Inter-Departmental Memorandum

Date: May 18, 2015

Subject: Removal of Detour Roads and Existing Embankment

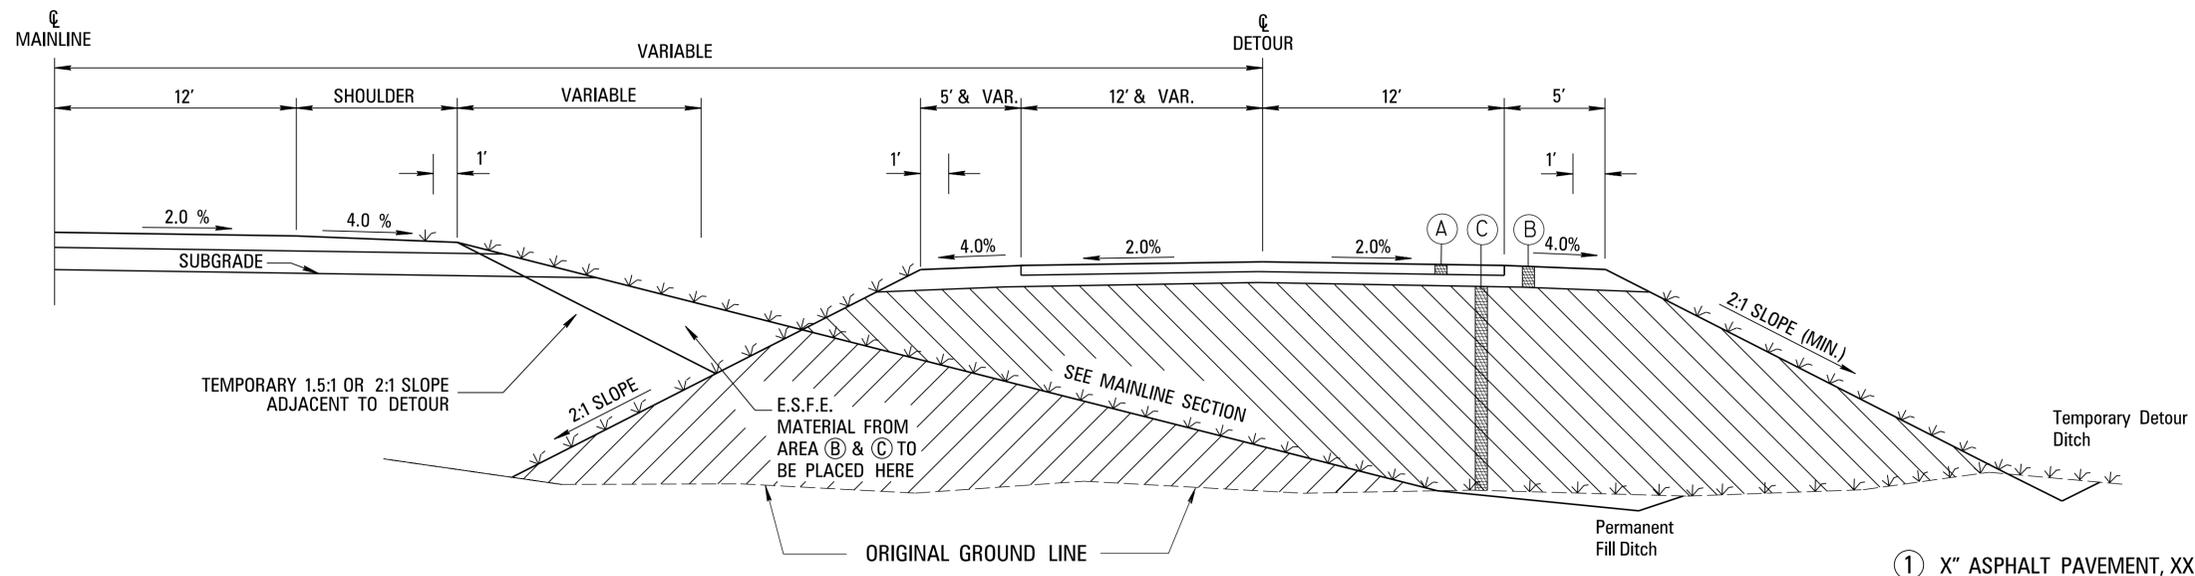
A Help document has been created showing the steps to create the removal of detour road in the cross-sections, along with a XS hatch button in the DZine menu to aid in this process. An example of the cross-hatching on the cross-sections is attached.

Beginning immediately, detour bridge recommendations will state that the detour road must be removed within the floodplain determined by the base flood elevation, or station limits will be included. The areas to be removed are to be shown cross-hatched on the cross-sections. Hydraulics Division will be checking the cross-sections on field inspections to make sure this has been properly addressed.

TYPICAL SECTION FOR CONSTRUCTION AND REMOVAL OF DETOUR ROAD

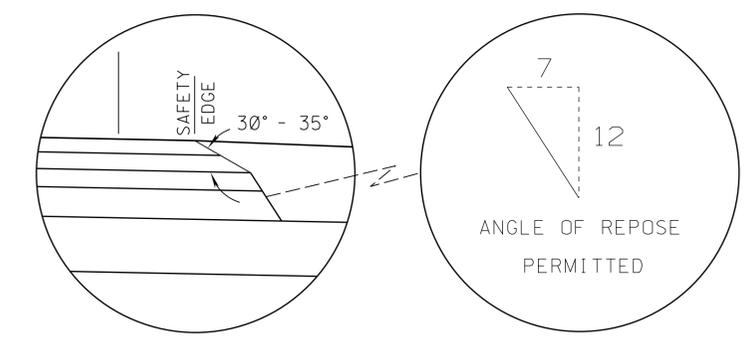
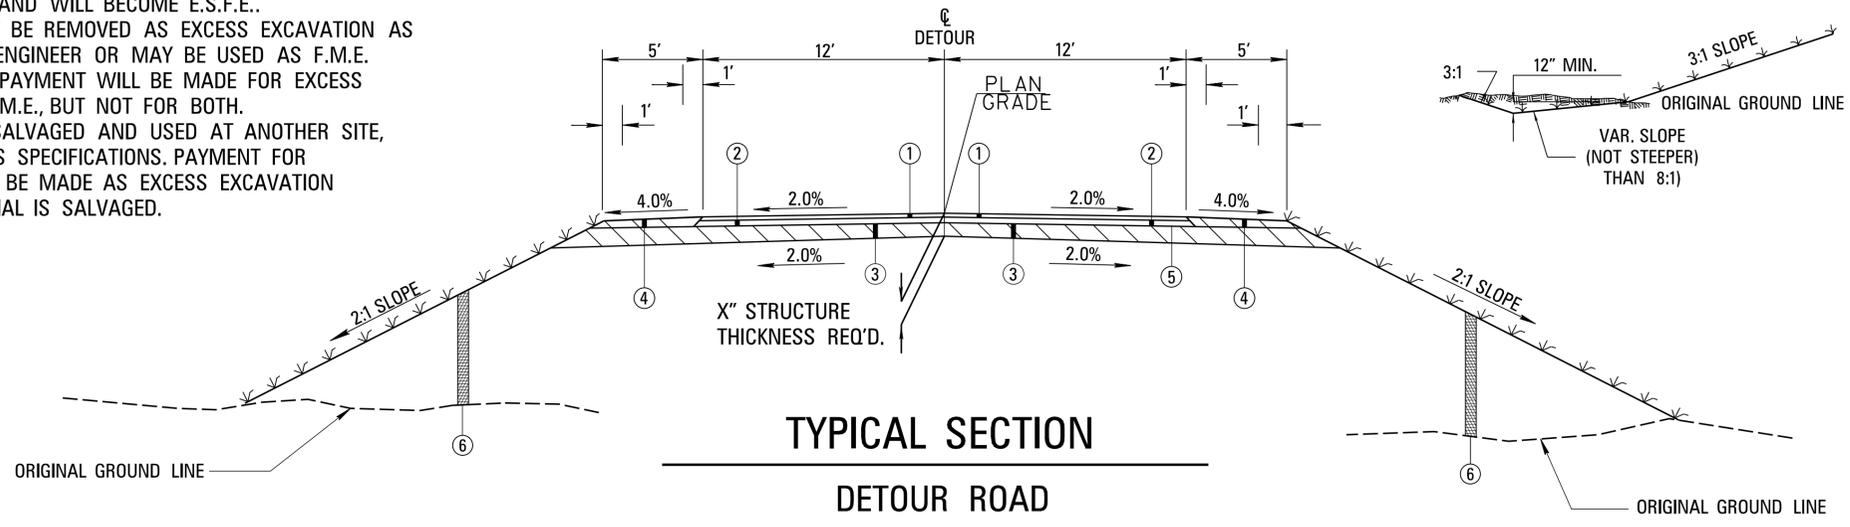
The cell for "Construction and Removal of Detour Road" has been revised and is attached. Also, a cell for "Removal of Existing Embankment" has been created and is also attached.

- NOTES:
- (A) -PAVEMENT
 - (B) -GRANULAR MATERIAL
 - (C) -BORROW EXCAVATION
 - I. WHEN NO LONGER NEEDED, THE DETOUR ROAD SHALL BE REMOVED TO THE EXISTING GROUND LINE.
 - II. AREA (A) WILL BE REMOVED AND PAID FOR UNDER APPROPRIATE PAY ITEMS.
 - III. AREA (B) & (C) WILL BE INCLUDED IN THE REMOVAL OF DETOUR ROAD AND WILL BECOME E.S.F.E.. AREA (B) & (C) MAY BE REMOVED AS EXCESS EXCAVATION AS DIRECTED BY THE ENGINEER OR MAY BE USED AS F.M.E. AT ANOTHER SITE. PAYMENT WILL BE MADE FOR EXCESS EXCAVATION OR F.M.E., BUT NOT FOR BOTH. AREA (B) MAY BE SALVAGED AND USED AT ANOTHER SITE, PROVIDED IT MEETS SPECIFICATIONS. PAYMENT FOR AREA (B) WILL NOT BE MADE AS EXCESS EXCAVATION WHEN THE MATERIAL IS SALVAGED.
